Reference: H14/0918/91 Received:02-OCT-91 Type:CONDITION COMPLIANCE

Description: Kitchen window detail required

Location : The Old Church School St Batholomews Church
Six House Bank West Pinchbeck, Spalding,Lincs

PROPOSED PART DEMOLITION and RENOVATION to OLD CHURCH SCHOOL.

January 1991 · Scale : 1:100 · Dwg. no. 3 ~~A~~ C (ELEVATIONS)
November

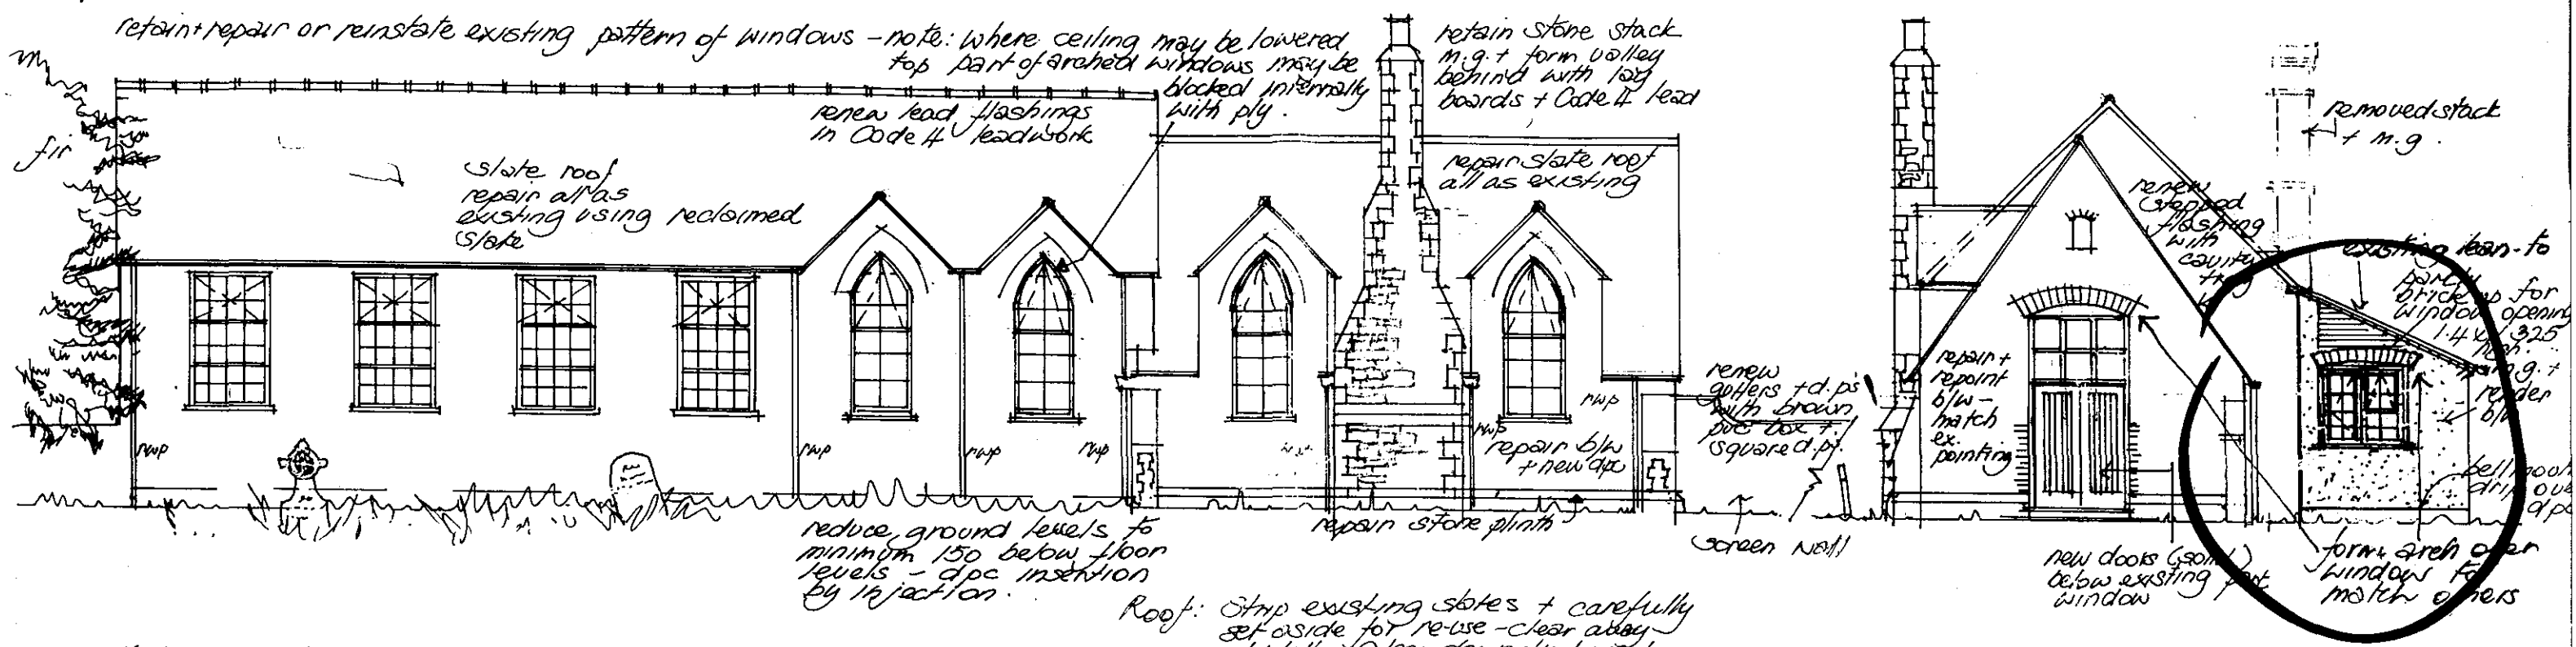
PSV I see a soldier and is gorgeous - I think a carved or gauged arch would be better. They must have gauged bricks available from the demolition site.

I note that it is proposed to have a flat soldier course over the windows which is a modern design solution. I suggest that a more suitable approach would be an arched course over the window to match other retained windows with this detailing. Alternatively some of the windows in the part of the building to be demolished have a gauged arch which could be retained and reused at this window.

I would be pleased if you would consider this suggestion and submit revised drawings showing either of these features.

This was in compliance with your request for an arched course over and above the Planning condition 3,in your letter dated5th November 1991. We trust that this window now now meets with all possible requirements.

"Universal" arch to lintol to provide coursed brick arch over window to match others on site

January 1991. Scale: 1:100. Dwg. no. 2 A,B,C,D (GROUND PLAN) with window detail. (b - new store + Fire Report)
November/March 1992 (D)

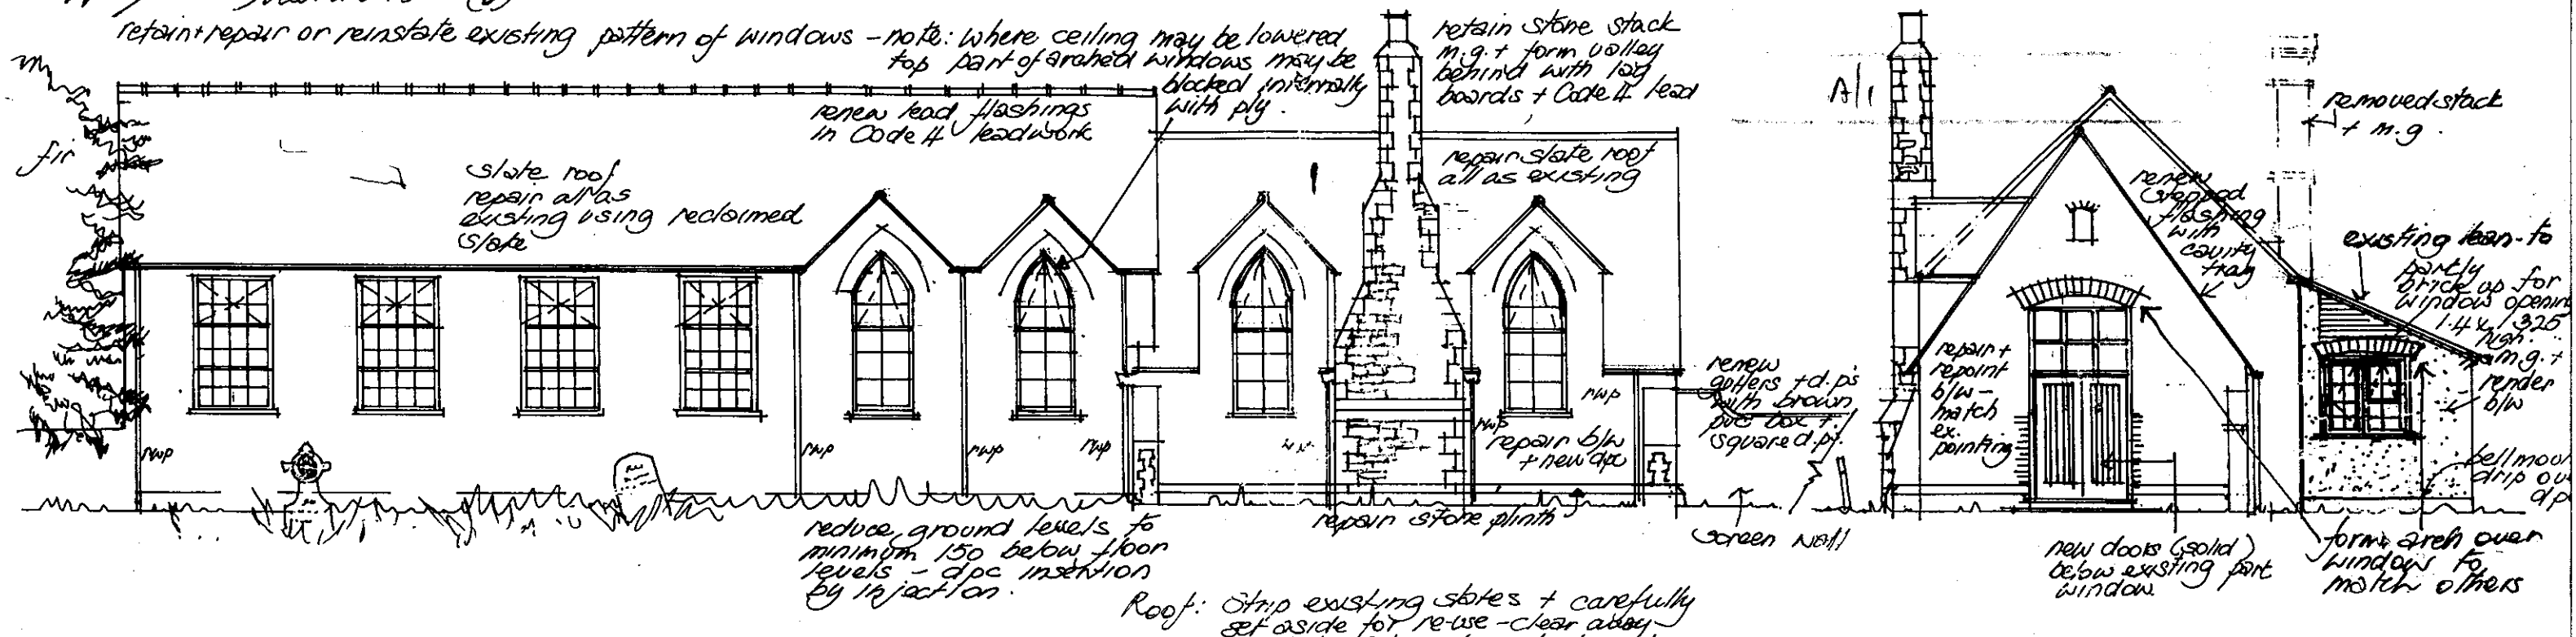
Since receiving the Planning and Building Regulation approvals, the Chief Fire Officer has requested a fire escape door to be fitted at the end of the main hall and this is now indicated on the enclosed amended plans together with a new small store area acheived by extending the existing lean-to roof at the rear of the premises.

fit new Fire Escape door in partly blocked window + provide concrete landing 900m² externally to project beyond door swing (see Fire Report)

"Universal" arch to lintol to provide coursed brick arch over window to match others on site.

January 1991 · Scale : 1:100 · Dwg. no. 3 3rd & D (ELEVATIONS) (FIRE REPORT & STORE)* to be read in conjunction with Fire Report dated 17.2.1992
November March 1992 (D)

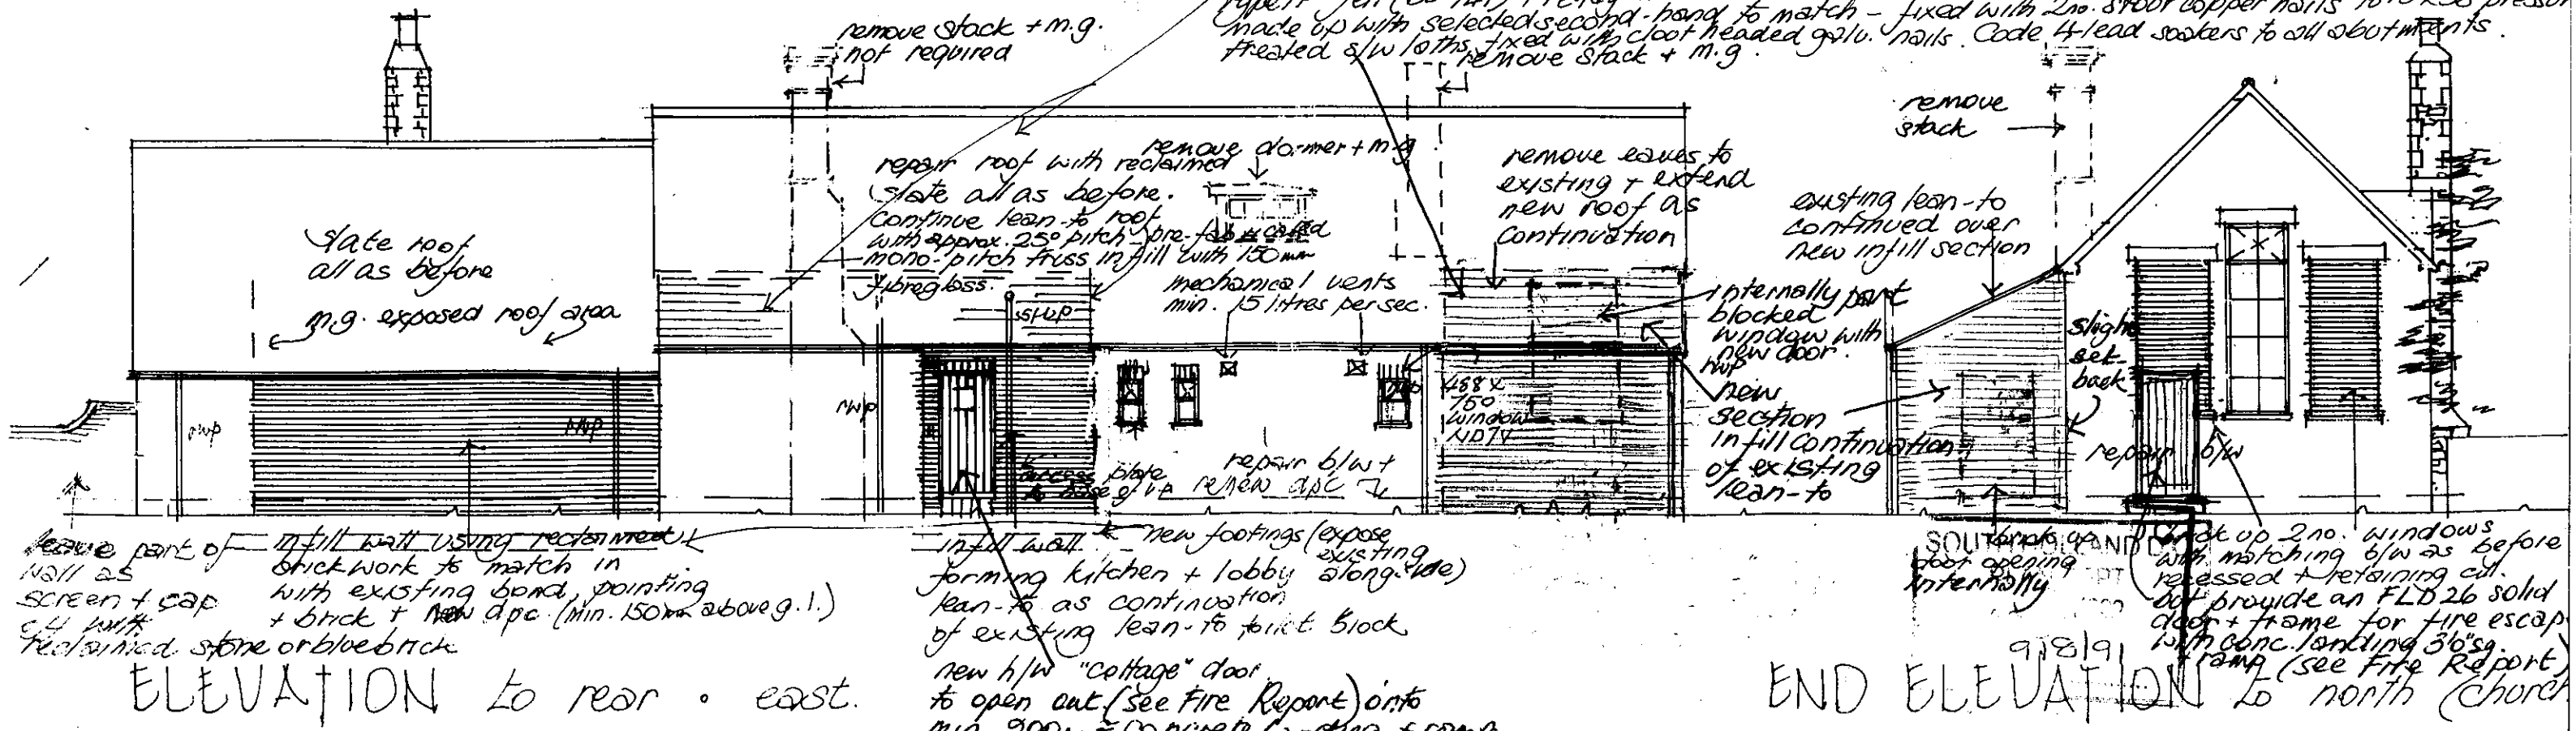
I have received details of the above development which you wish to have accepted in lieu of those previously submitted. However, I consider that the changes are too significant to be treated merely as an amendment and that therefore a fresh application for planning permission should be submitted (forms enclosed).
